# STATE OF VERMONT AGENCY OF TRANSPORTATION

## PROPOSED IMPROVEMENT STATEWIDE RAILROAD CROSSINGS (SOUTHERN) COUNTY OF BENNINGTON TOWNS OF NORTH BENNINGTON MANCHESTER SHAFTSBURY TH 3, CL.2 (17-URBAN COLLECTOR) TH 1, CL.1 (16-URBAN MINOR ARTERIAL) TH 4, CL.2 (9-LOCAL ROAD) TH 9, CL.2 (7-RURAL MAJOR COLLECTOR) TH 7, CL.2 (9-LOCAL ROAD)

RECORD PLANS	
CONTRACTOR:	ECI RAIL CONSTRUCTORS, INC. - SO. BURLINGTON, VT
RESIDENT ENGINEER:	MARK HAUGHWOUT
CONSTRUCTION BEGAN:	JULY 16, 2007
CONSTRUCTION COMPLETE:	JANUARY 8, 2008
RECORD PLANS BY:	MARK HAUGHWOUT & N GARBACIK
I HEREBY CERTIFY THAT ALL THE CONSTRUCTION REQUIRED BY THIS SET OF DRAWINGS HAS BEEN ACCOMPLISHED AS INDICATED HEREIN.	
BY:	<i>Mark W. Haughwout</i> RESIDENT ENGINEER
DATE:	10/31/08
NOTE: Any further information concerning final quantities, amounts or other details relative to this project may be found at Central Files in the electronic archives.

DIRECTOR OF PROGRAM DEVELOPMENT	APPROVED: <i>Richard J. Filante</i> DATE: <i>01/08/08</i>
PROJECT MANAGER:	JENNIFER ROYER
PROJECT NAME:	STATEWIDE RAIL XING SOUTHERN REGION (RE-ADVERTISED)
SHEET 1 OF 21 SHEETS

**PLAN - UNION STREET**  
**AARDOT # 851-199R**

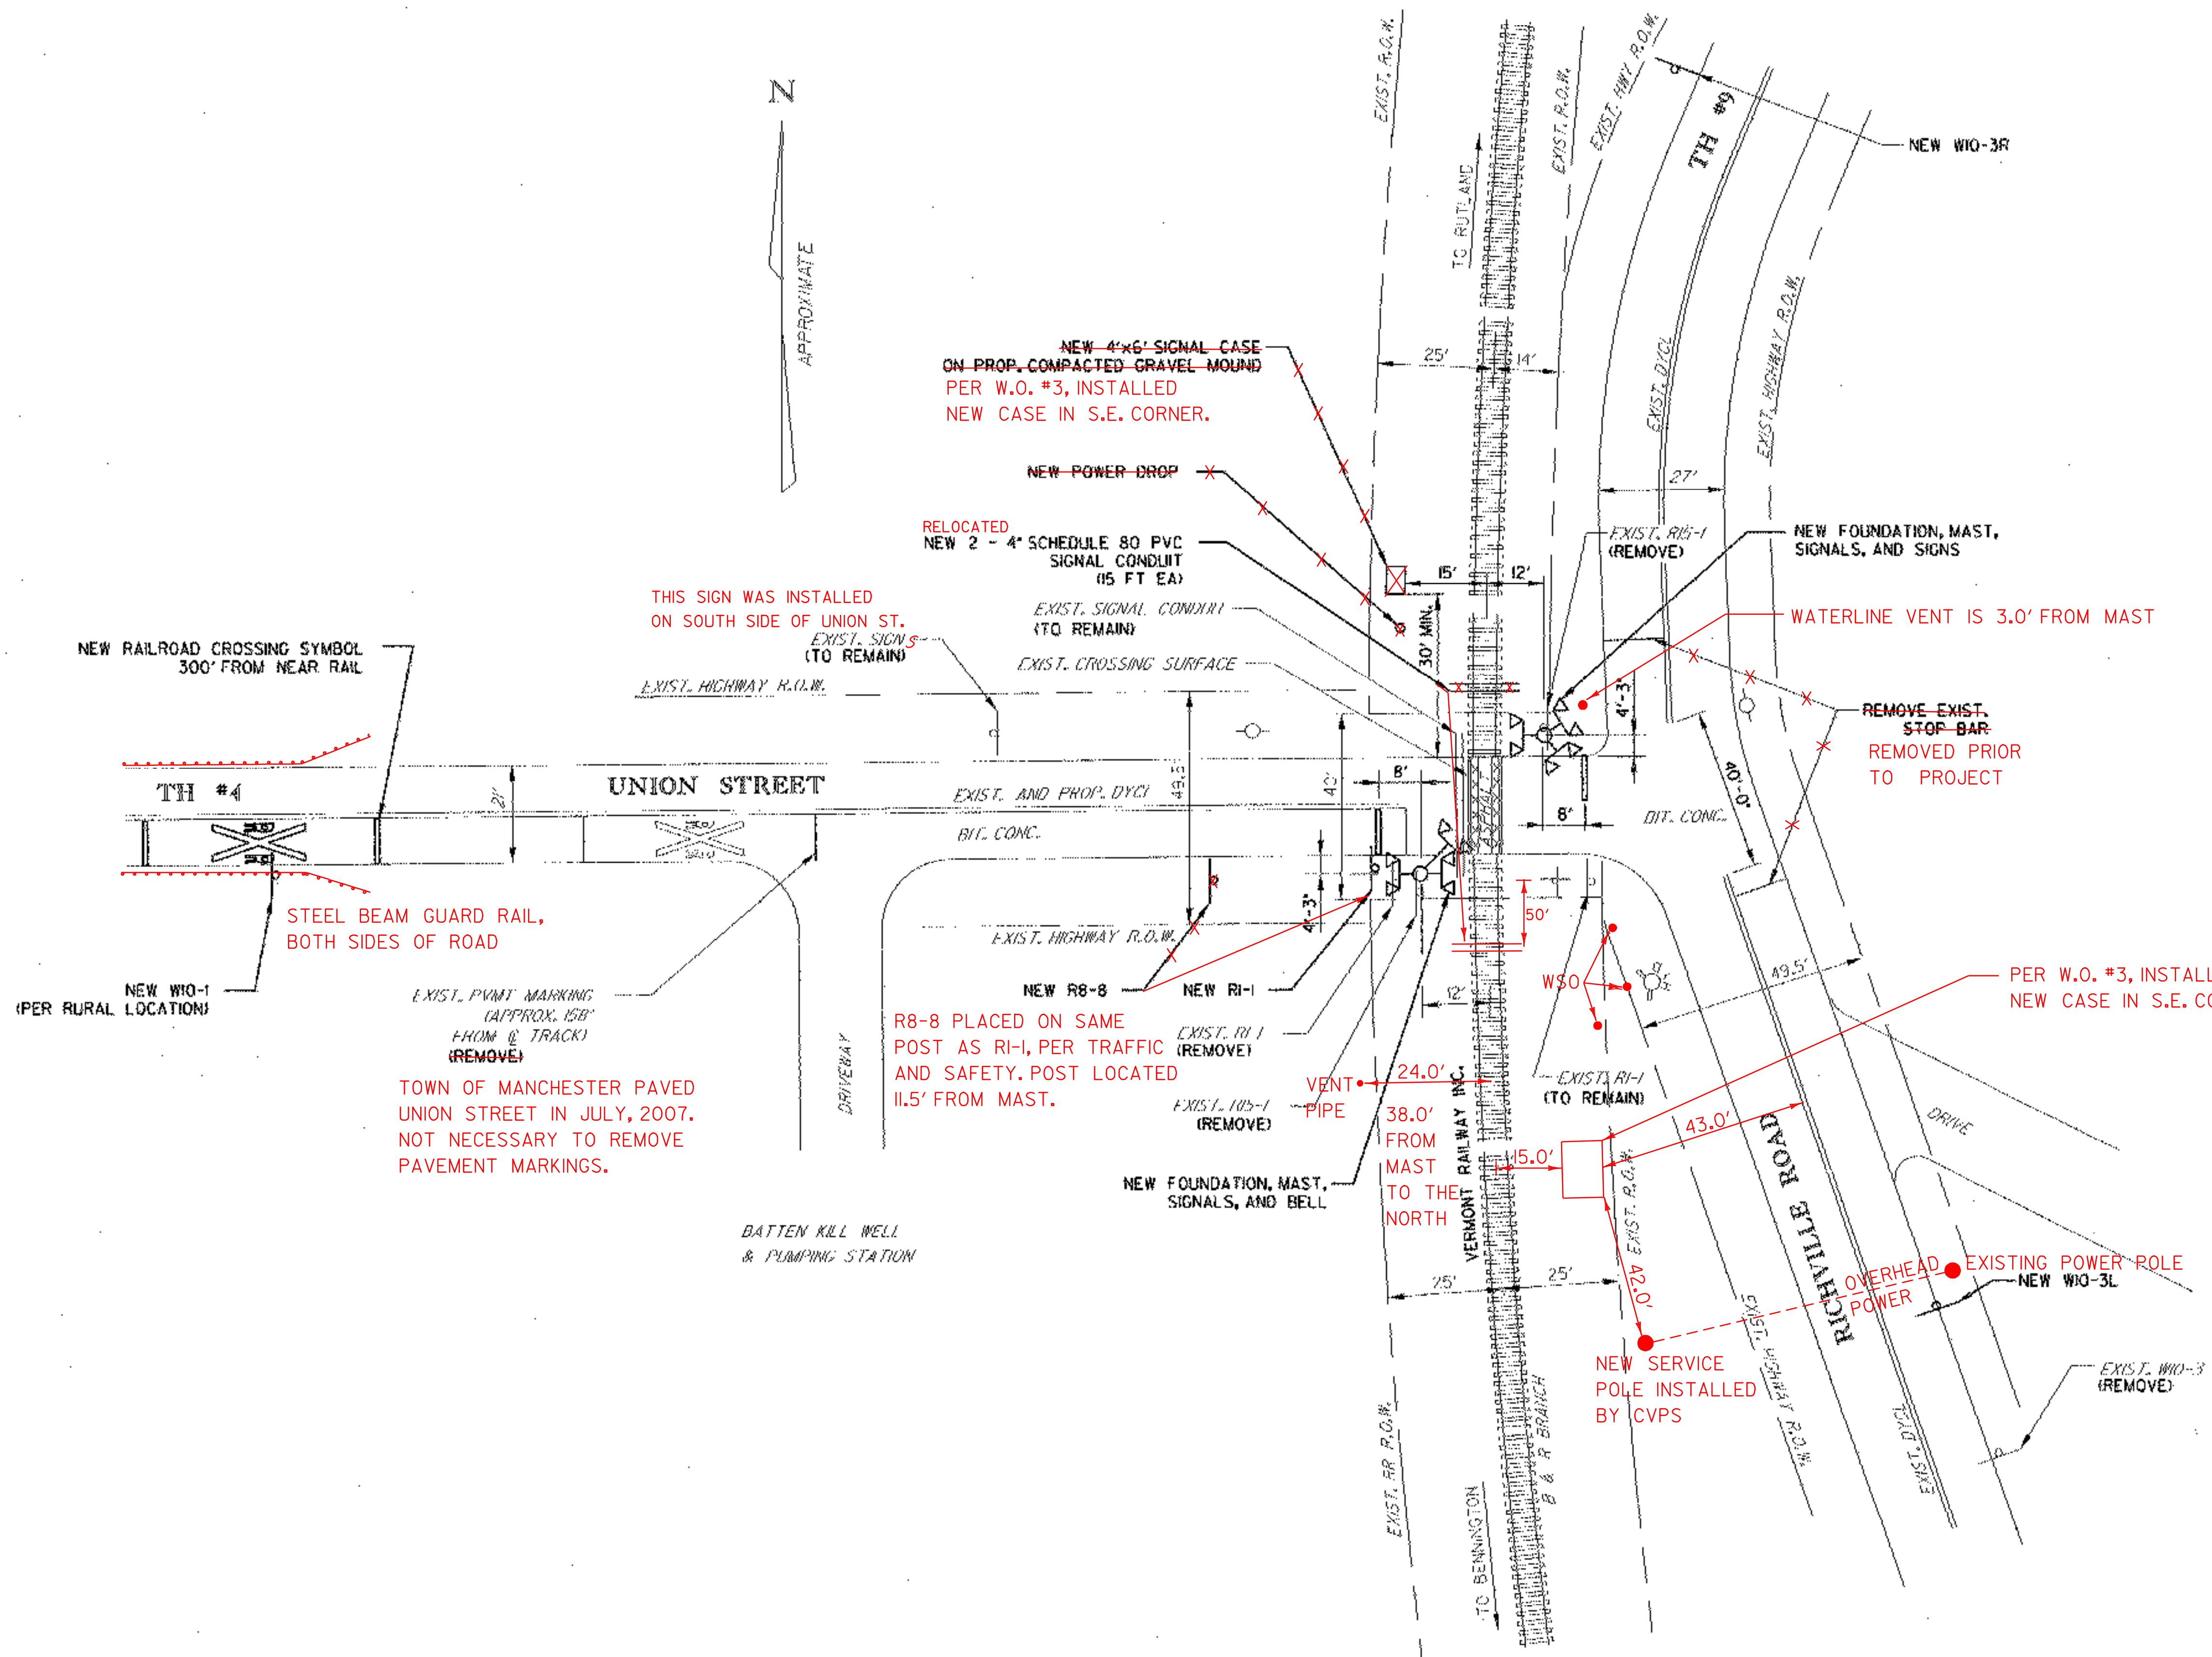
- \* HYDRANT IS 22' FROM NEAR CORNER (N.E.) OF NEW SIGNAL CASE. IS 12.5' FROM NEAR EDGE OF PAVEMENT.
- WSO #1 IS 17.5' FROM NEAR CORNER (N.E.) OF NEW SIGNAL CASE. 4.5' FROM HYDRANT.
- WSO #2 IS 20.5' FROM NEAR CORNER (N.E.) OF NEW SIGNAL CASE. 2.0' FROM HYDRANT.
- WSO #3 IS 31.0' FROM NEAR CORNER (N.E.) OF NEW SIGNAL CASE. 9.5' FROM NEAR EDGE OF PAVEMENT

**PLAN - RICHVILLE ROAD**  
**AARDOT # 851-200H**

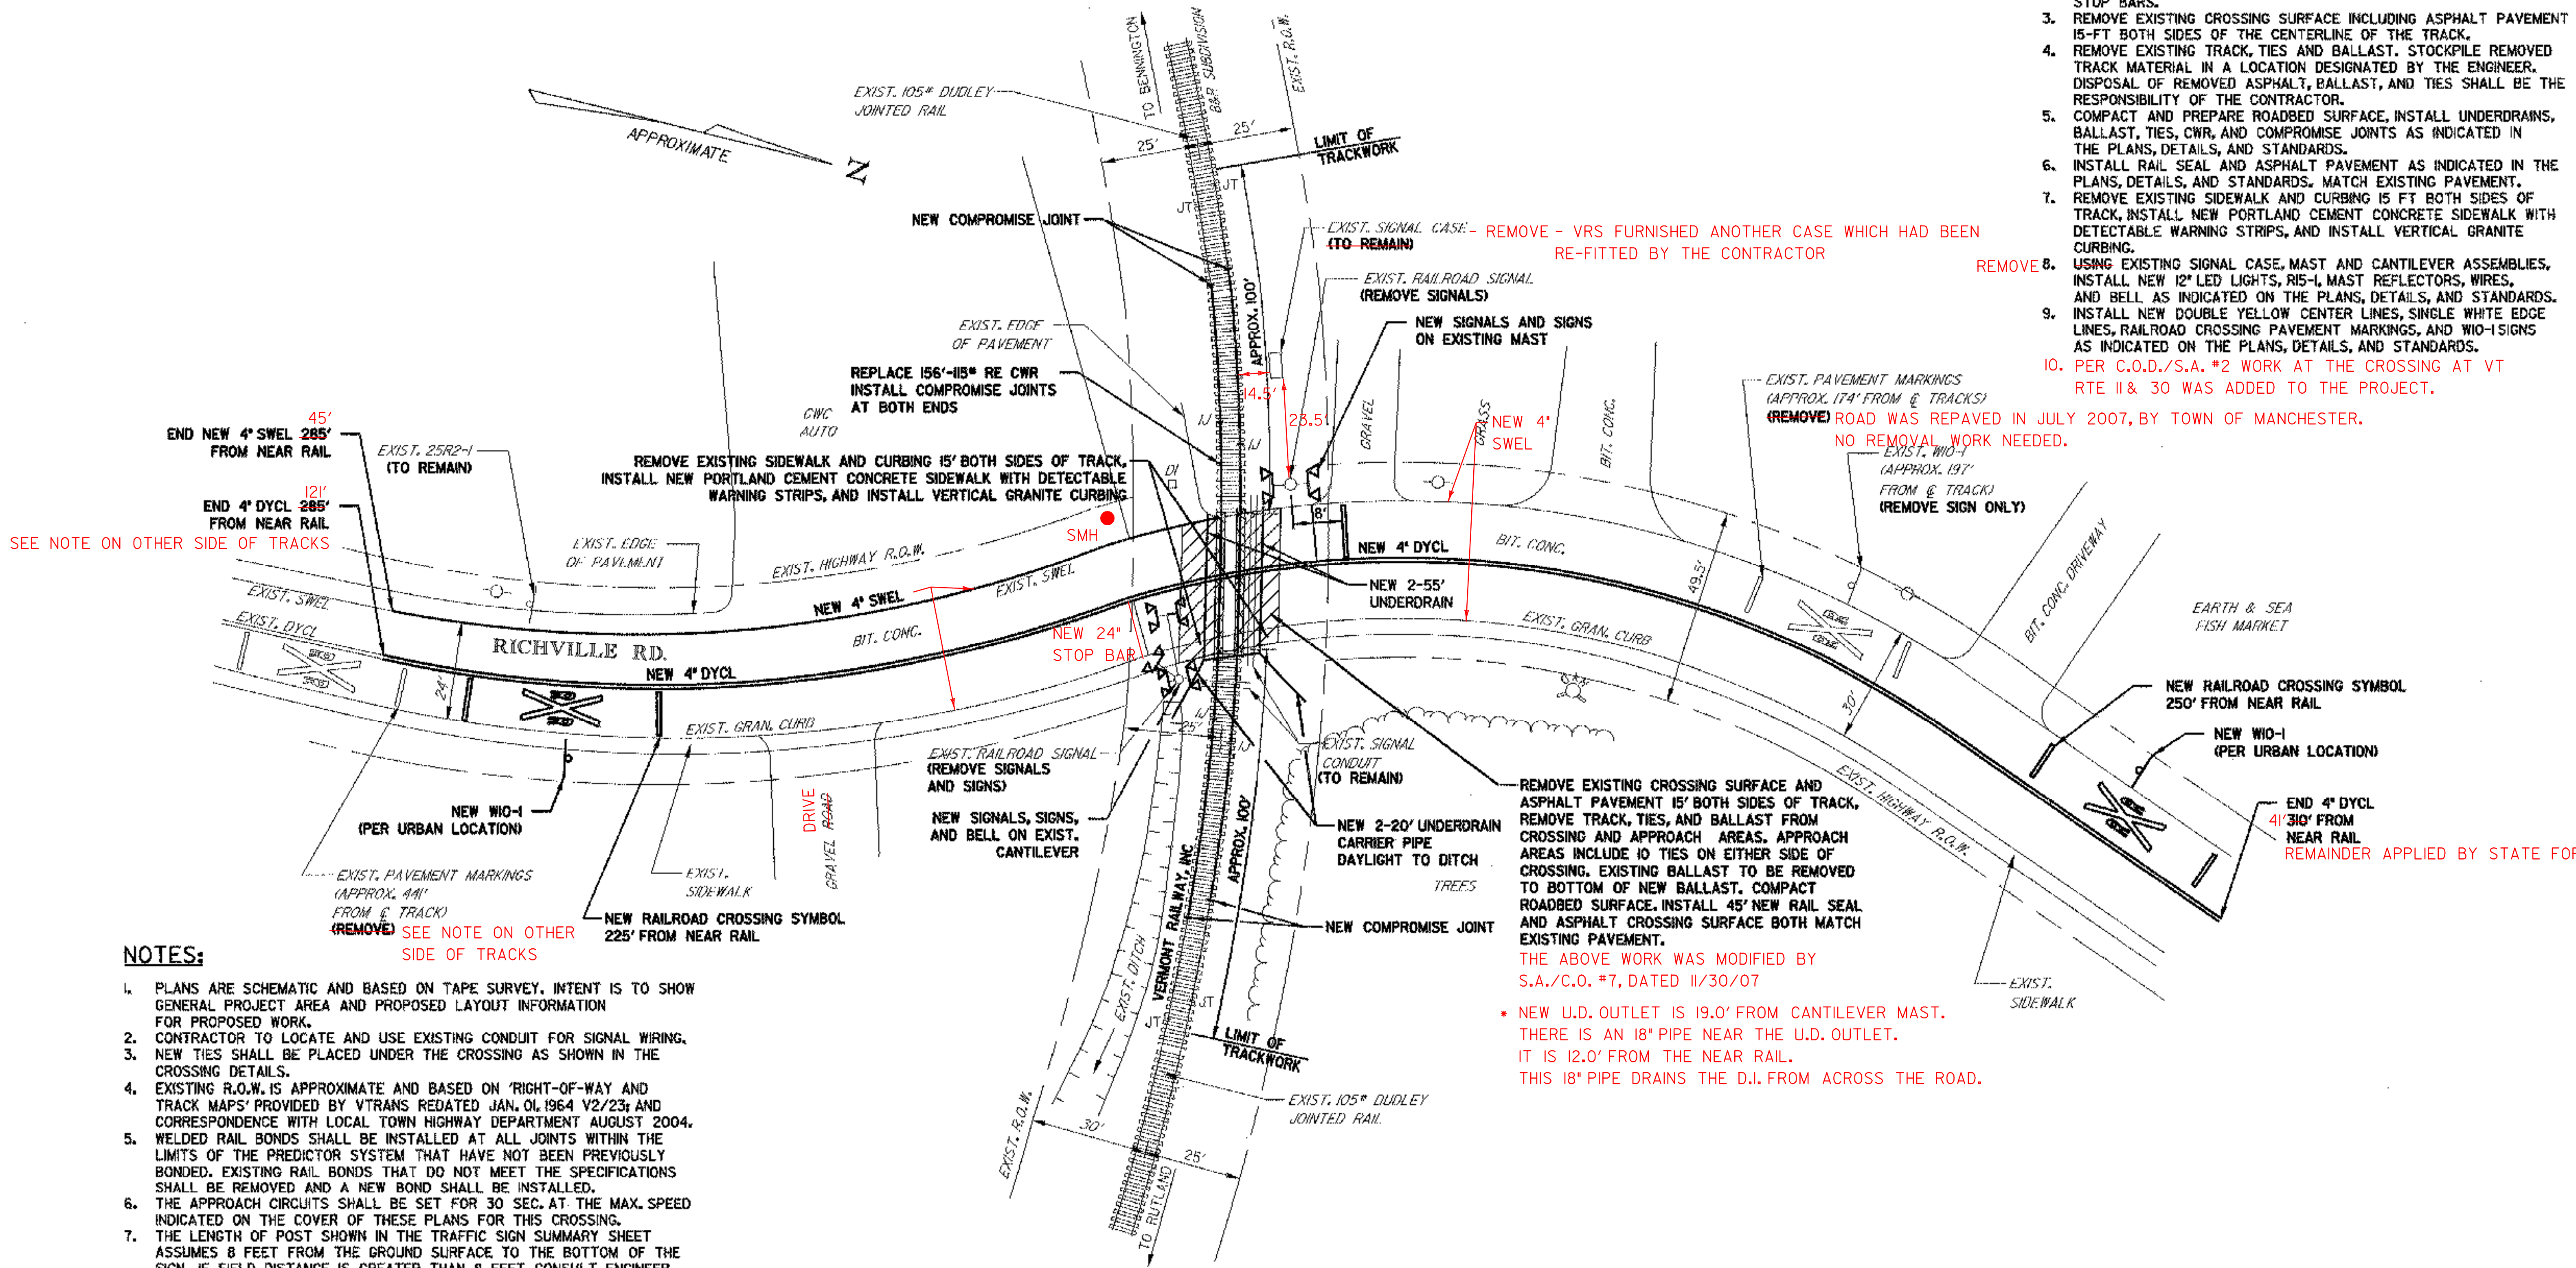
10. PER C.O.D./S.A. #2 WORK AT THE CROSSING AT VT RTE II & 30 WAS ADDED TO THE PROJECT.

SEE NOTE ON OTHER SIDE OF TRACKS

NO REMOVAL WORK NEEDED.

REMAINDER APPLIED BY STATE FORCES

PLAN - AIRPORT ROAD  
AARDOT # 851-173N

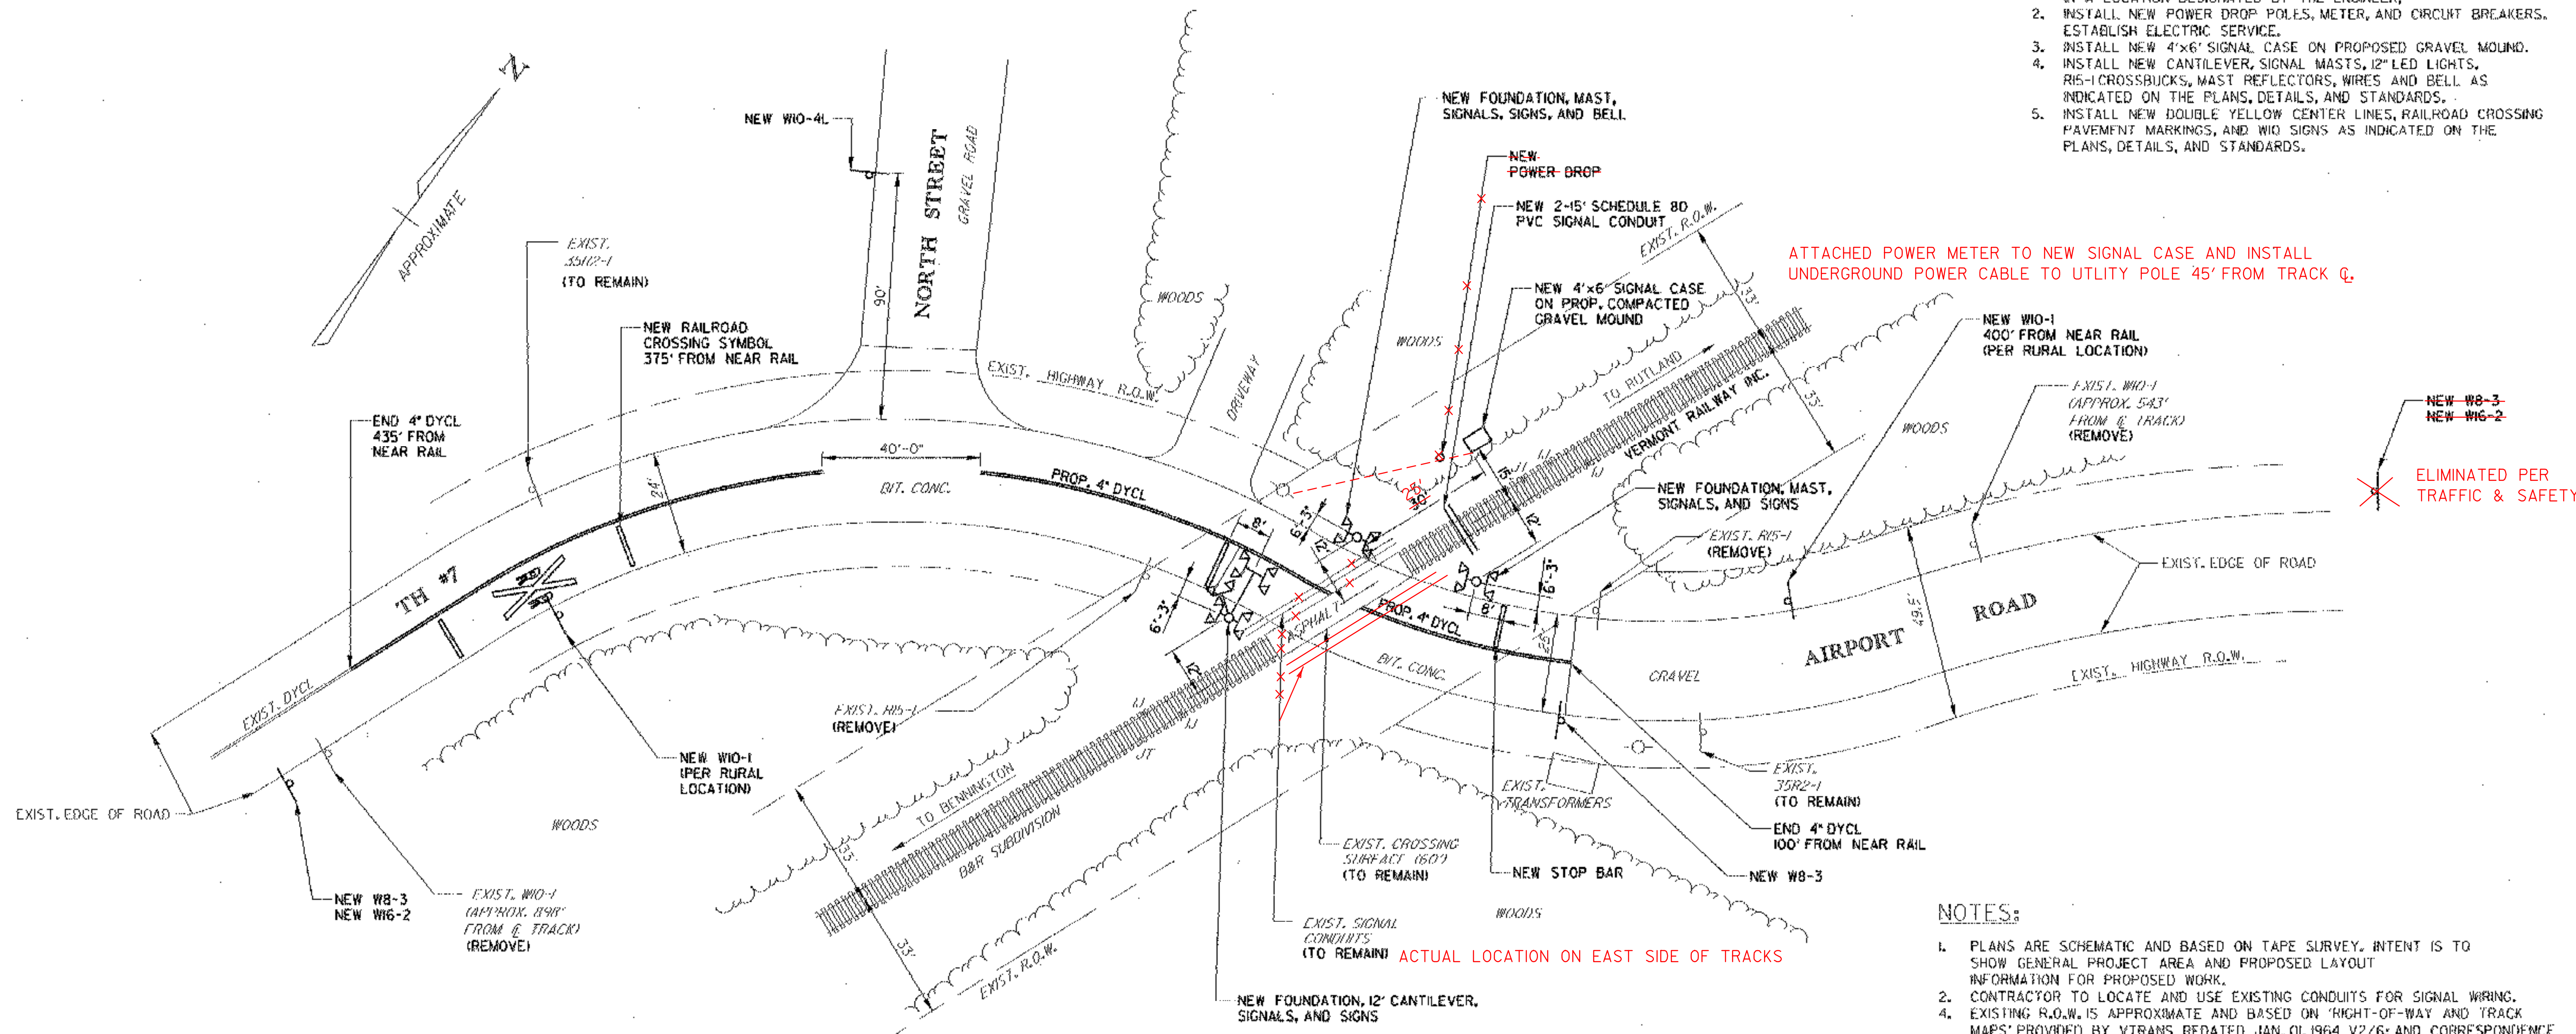
ATTACHED POWER METER TO NEW SIGNAL CASE AND INSTALL UNDERGROUND POWER CABLE TO UTILITY POLE 45' FROM TRACK Q.

ELIMINATED PER TRAFFIC & SAFETY
